ABB Components' Newsletter

September 1999

New UCG design

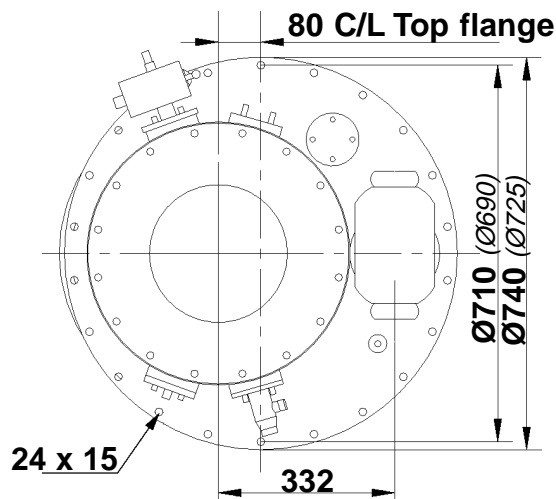
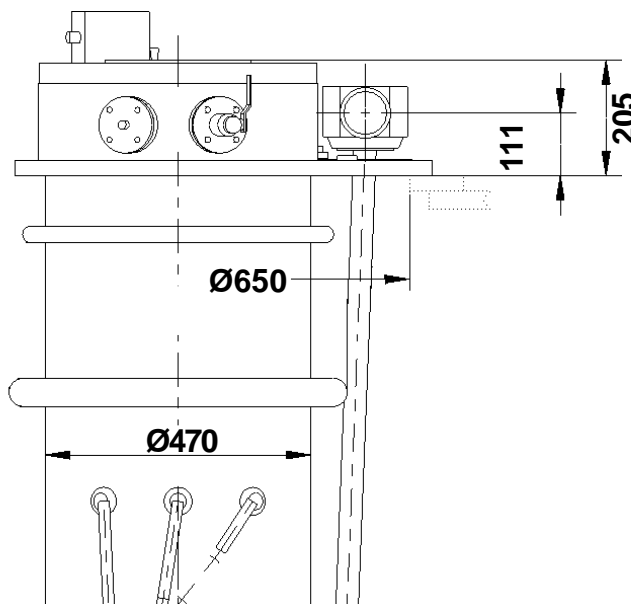
- The cylinder is fastened with rivets instead of with glue.
- New flange dimensions. New diameter is **740 mm**, was *725 mm*.
- New hole circle **710 mm**, was *690 mm*.
- The number of holes are **24**, was *22*.
- New cylinder diameter **470 mm**, was *420 mm*.
- New hole dimension in transformer. New diameter is **650 mm**, was min. *635 mm*.
- The bevel gear angle can be adjusted between 0° and 180°.
- The top section is painted grey-blue as standard.
- The positioning of the accessories.

The new dimensions are shown below in bold writing, the old dimensions are shown in italic in brackets.
